REGIONAL REVIEW FINDING

ARC REVIEW CODE: R1702271

Name of Proposal: Liberty Industrial Park of Buford (DRI #2651)

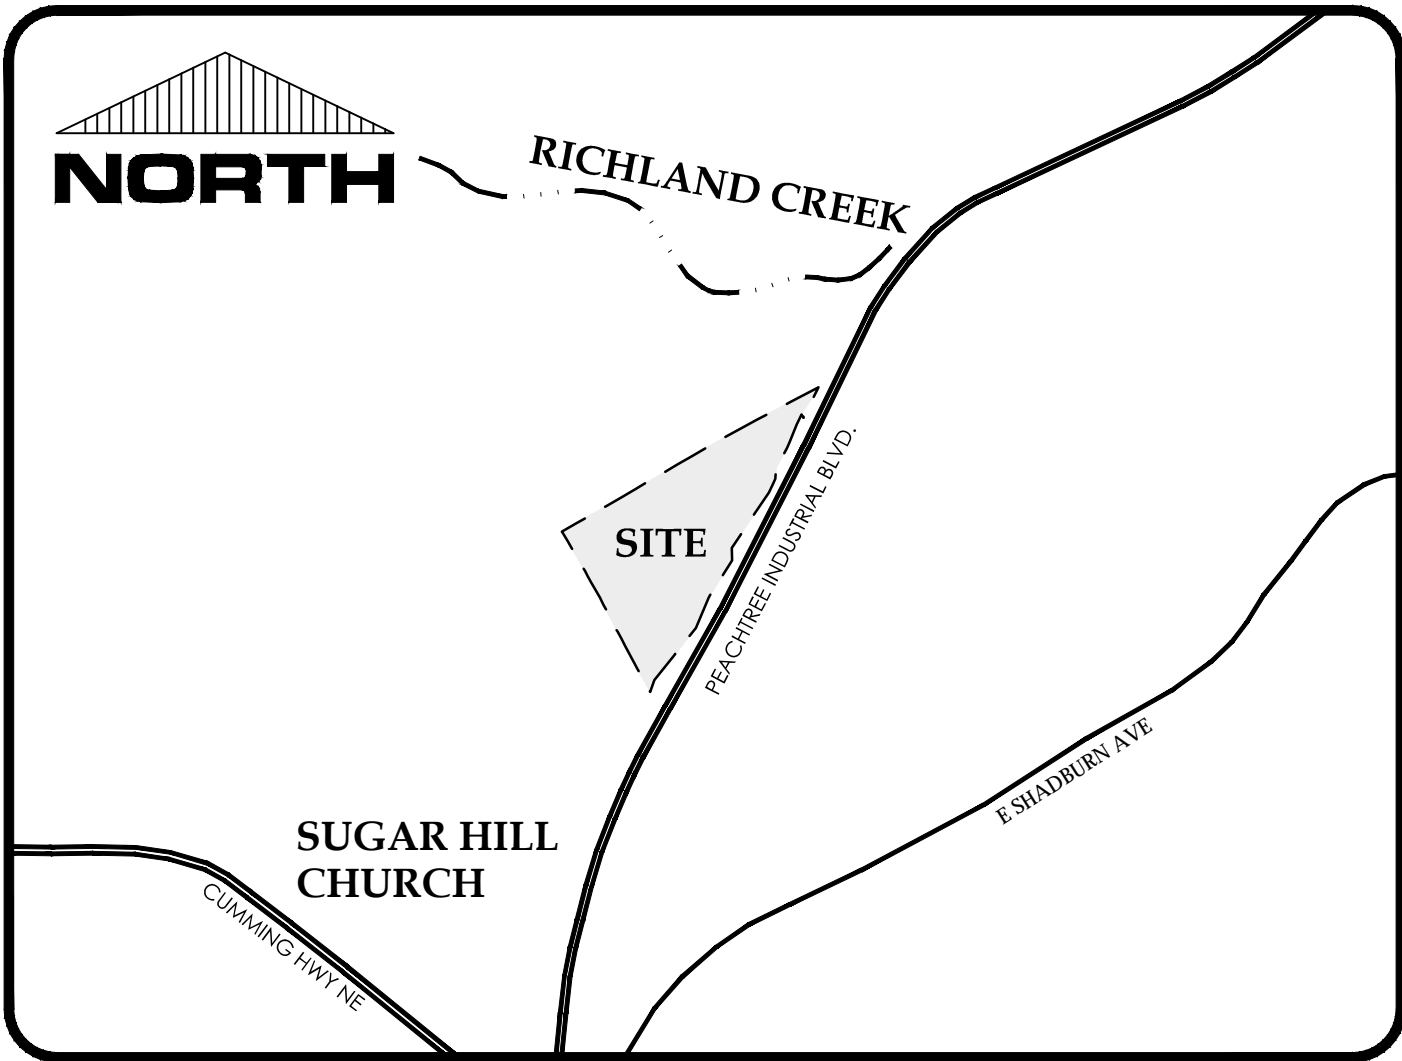
The USGS coverage for the project area shows two unnamed tributaries to Richland Creek on the project property. Neither is identified on the submitted site plan. The first stream appears to originate on the property in the vicinity of the proposed site of Building A. The second crosses the property at the northern end of its frontage along Peachtree Industrial Boulevard in the area marked as “Detention” on the project plans. There appear to be both a proposed building and parking on the submitted plans over the stream shown as originating on the property. A proposed driveway crossing (identified as Driveway 3 on the plans) and the previously referenced detention area appear to be located over the tributary crossing the site on the project plans. As no streams are indicated on the plans, no buffers are shown. If it is determined that these streams, or any other streams, are on the property, they will be subject to the buffers required under the Buford Stream Buffer Ordinance as well as the 25-foot State Erosion and Sedimentation buffer. Any proposed activity within the City’s stream buffers will be subject to the requirements of the Buford Stream Buffer Ordinance and may require variances. Activities within the 25-foot State Sediment and Erosion Control buffer are subject to state requirements and may also require a variance. Any other state waters on the property are also subject to the requirements of the State 25-foot Erosion and Sedimentation buffer.

The site depicts sidewalks existing along the Peachtree Industrial Boulevard ROW and internal interconnectivity for pedestrians being provided via sidewalks. No bicycle facilities are existing or being depicted.

The site plan shows external interconnectivity for pedestrians between adjacent developments currently exists and/or are proposed along Peachtree Industrial Boulevard via sidewalks along the right of way. No stub outs, bicycle facilities or inter parcel connectivity internal to the site is proposed.

The site plan depicts three access points, two of which show driveway lanes to accommodate both truck and vehicular traffic into the site. One driveway access point shows a drive lane designed for vehicles only, that leads into a vehicle parking lot. In addition, vehicle parking is separated from areas

designated for freight truck traffic. Vehicle parking areas with sidewalk connectivity are provided along all buildings.

This development borders established neighborhoods in the City of Sugar Hill zoned for single-family (RS-100/agricultural) and multi-family (townhome) residential (RM). Based on the site plan, no landscape buffers or plantings of any kind are currently being provided to shield the residents from unsightliness or noise that may result from the industrial uses. The industrial use of the property may be more incompatible with surrounding uses than the current zoning (C-2/General Business) shown on the site plan. Residentially zoned properties within the City of Sugar Hill would typically be protected from industrially zoned properties by a 50 foot to 100 foot buffer (depending on the type of use). The City requests that a landscaped buffer equivalent to the following be provided between the subject property and any residentially zoned property within the City of Sugar Hill:

An enhanced buffer consisting of at least a staggered double row of evergreen or semi-evergreen trees and shrubs native or adapted to the area. Trees shall be at least 6' tall at time of planting. Plantings shall be arranged to provide an effective visual screen of at least 20' in height at maturity. Buffer must not contain more than 30% of a single species and must be shown on the landscape plan to be approved by Planning and Development prior to receiving any permits. Within enhanced buffer, any existing tree over 12" diameter at breast height (DBH) is to be preserved (except those identified as dead or dying).

Additionally, the City requests that the unnamed tributaries to Richland Creek located on the project property not be disturbed in any way that would impact the flow into the City of Sugar Hill or stormwater management of adjacent properties within the City.
